Docket Item # 10 & 11 BAR CASE # 2015-00242 & 2015-00243

BAR Meeting September 2, 2015

ISSUE: Permit to Demolish/Capsulate & Certificate of Appropriateness

LOCATION: 201 S. Lee Street

1.03

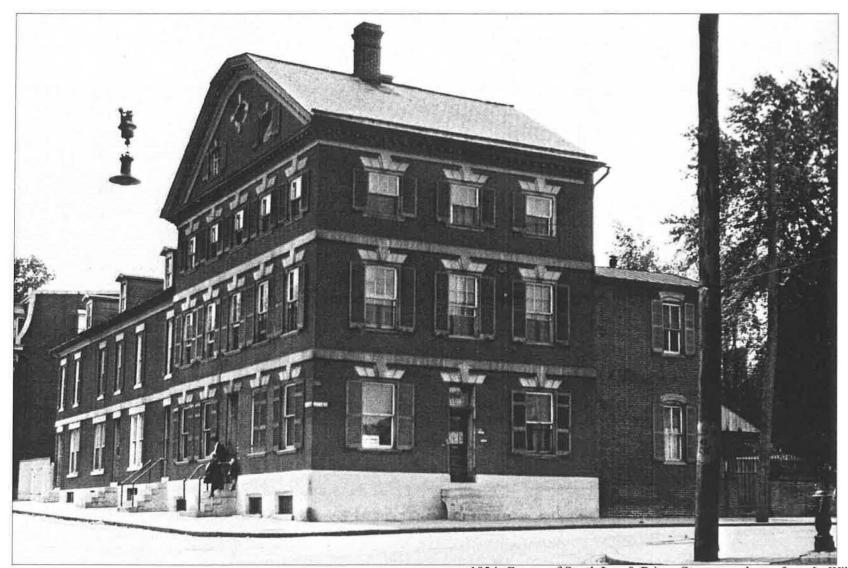
However, the proposed light configuration of the replacement windows does not appear to match what is shown in the historic photographs. Staff believes that the first floor double hung windows were nine-over-six and the attic windows were six-over-three (page 1.03) and that the glass sizes of the remaining windows should be adjusted accordingly in scale. Staff has inspected the windows, and the few Victorian-era windows that still remain on the house do not contain significant portions of wavy glass or unusual craftsmanship. The two-over-two window to be capsulated on the north elevation of the southern ell contains two panes of antique glass and the one-over-one windows on the east elevation contain none. Restoring the property to its 18th century period of significance would necessitate the removal of at least the one-over-one windows and staff supports this alteration. Staff recommends approval of the window replacement with the condition that the new windows comply with the *BAR Window Policy*, and with an appropriate muntin profile and light configuration.

- 1. That the final window specifications be submitted with a revised light configuration and muntin width for staff approval;
- 2. That the existing driveway gate be retained or the applicant return to the Board with a comparable replacement;

4.04

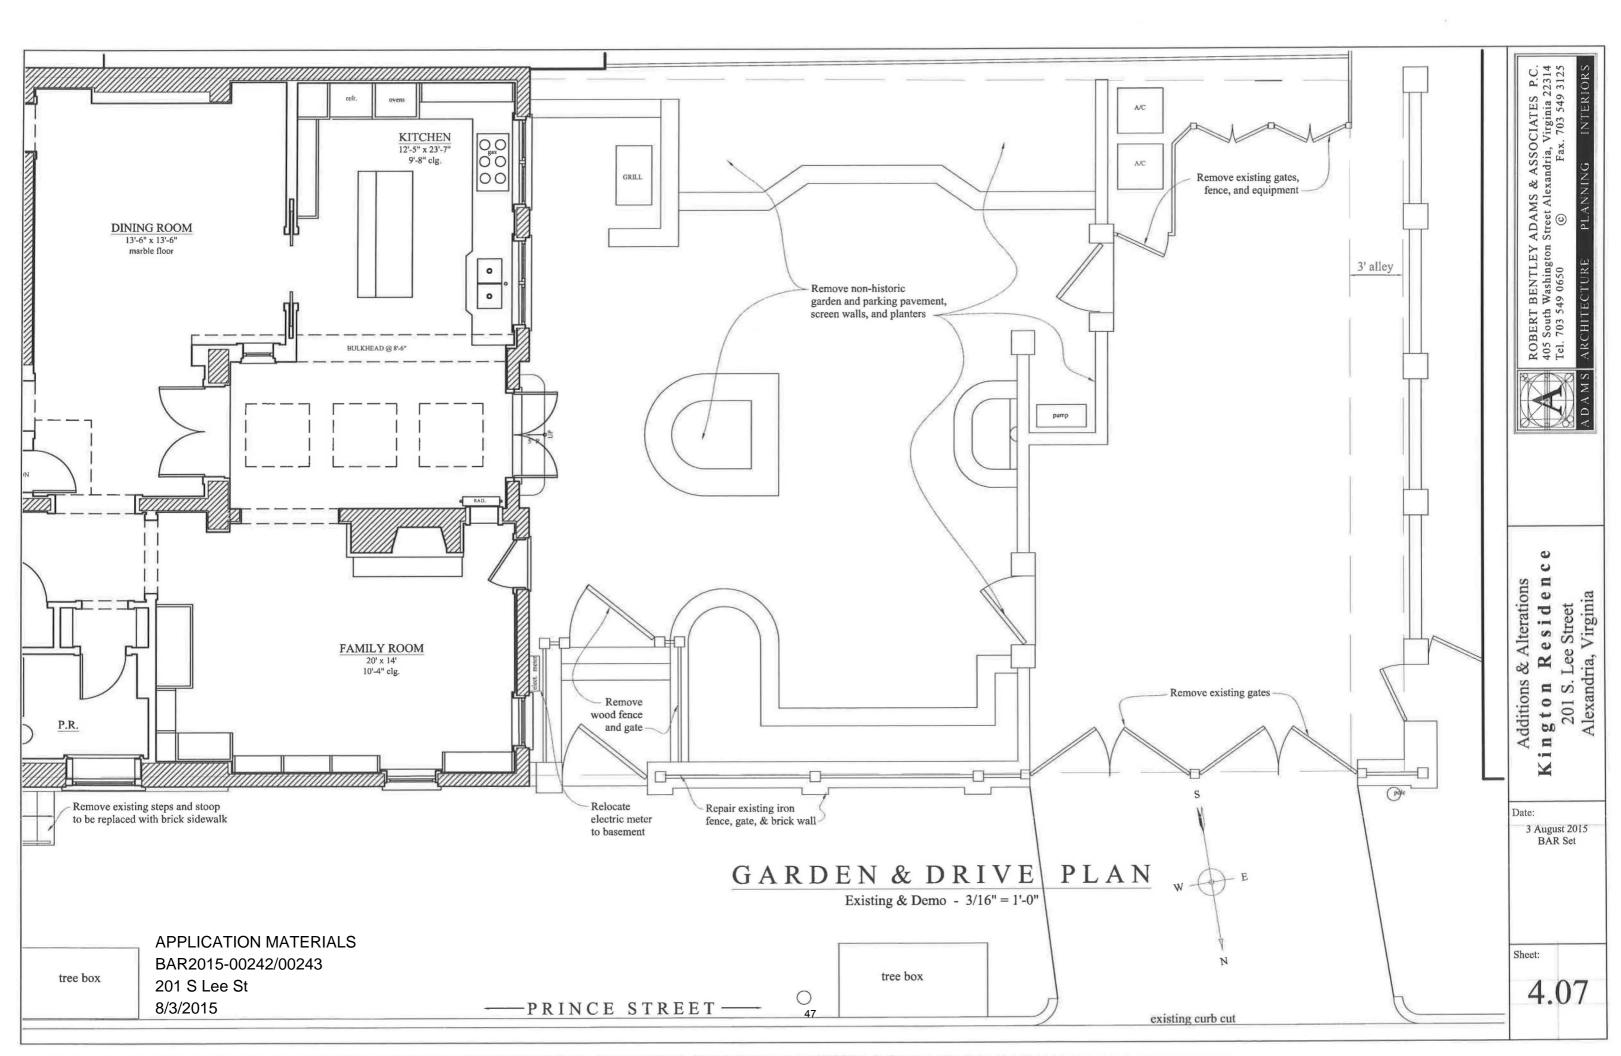
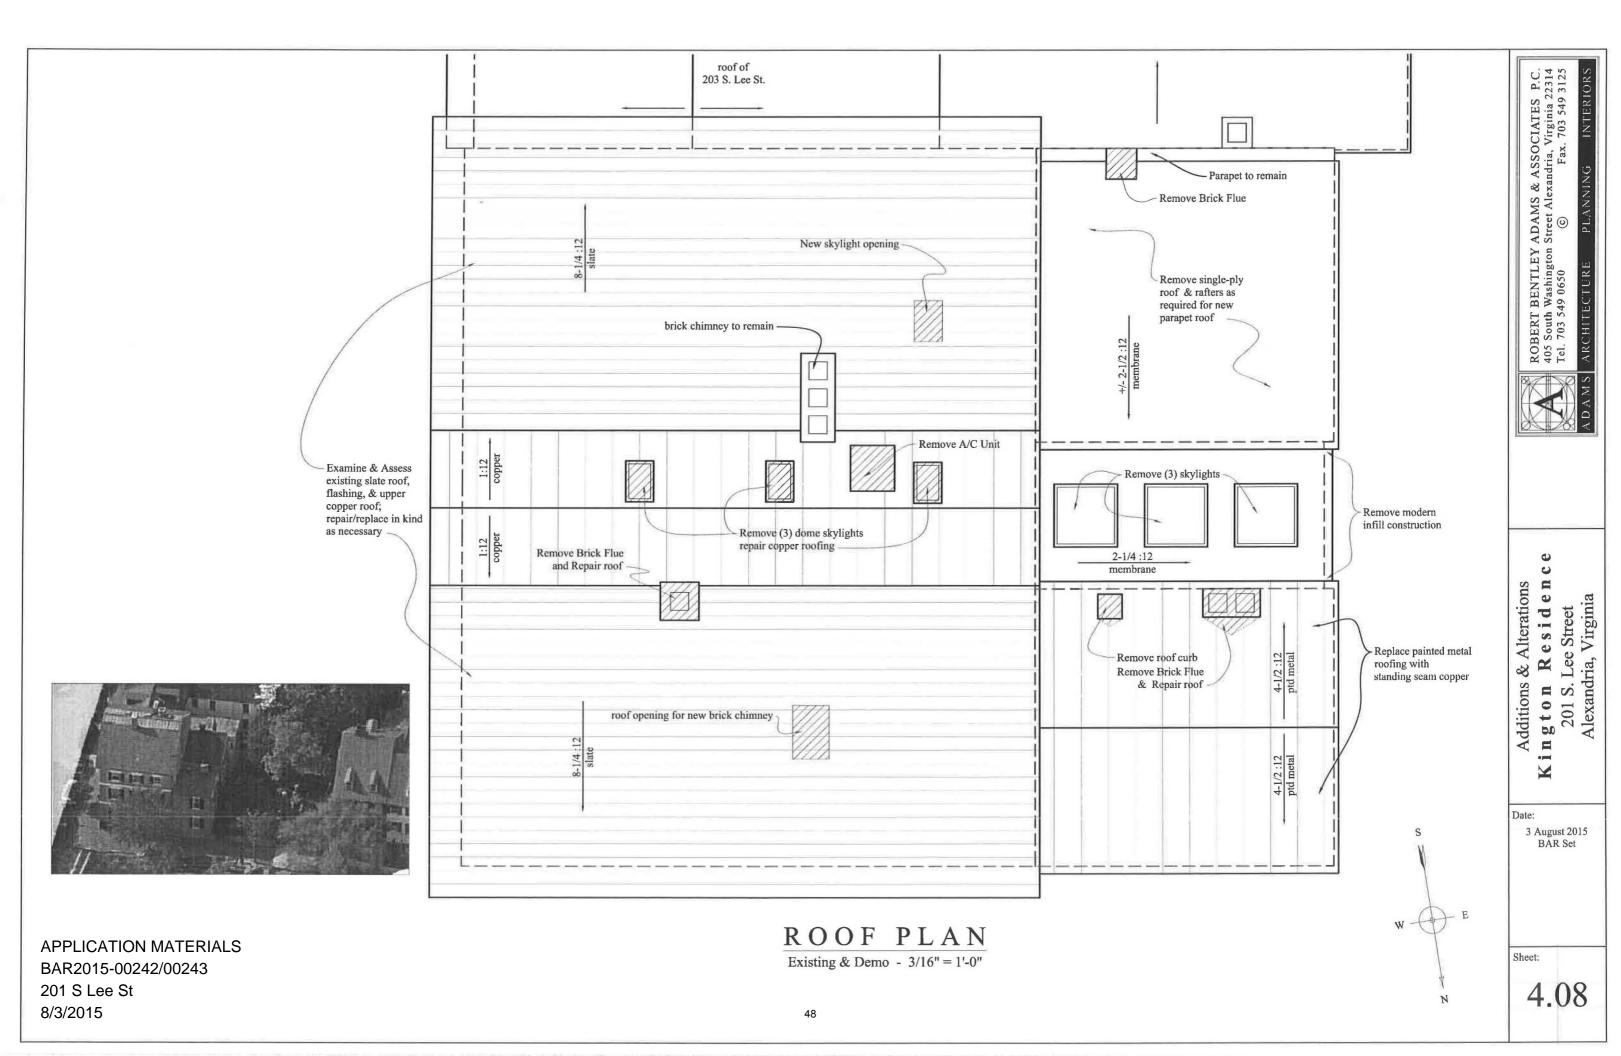
Staff recommends the Board defer the request for a Permit to Demolish the roof slope of the southern ell. The applicant requests a Permit to Demolish and rebuild the roof flat, so that it can accommodate rooftop mechanical equipment. Staff strongly supports the goal of screening the mechanical units from public view but suggests that other alternatives be explored, such as ground located units, so that the roof framing and form does not have to be altered. Criteria 1 and 3 are met and the Board generally does not support the wholesale demolition of roof

framing, particularly on 18th and 19th century structures. Presumably, the existing roof was built between 1902 and 1912, however staff has not had the opportunity to examine the framing in greater detail. If the roof framing is determined by the BAR to be insignificant, then staff recommends that the shed slope of the west wall of this south ell be preserved to reflect the original roof form and integrated into the screening balustrade. Therefore, a deferral for restudy is recommended in order to determine the age and significance of the roof framing as well as to explore alternative locations for the equipment that will maintain the historic roof form.

- 3. Deferral for restudy of the Permit to Demolish the roof of the southern ell;
- 4. Denial of a Permit to Demolish the north wall of the north ell in order to accommodate four new windows; and
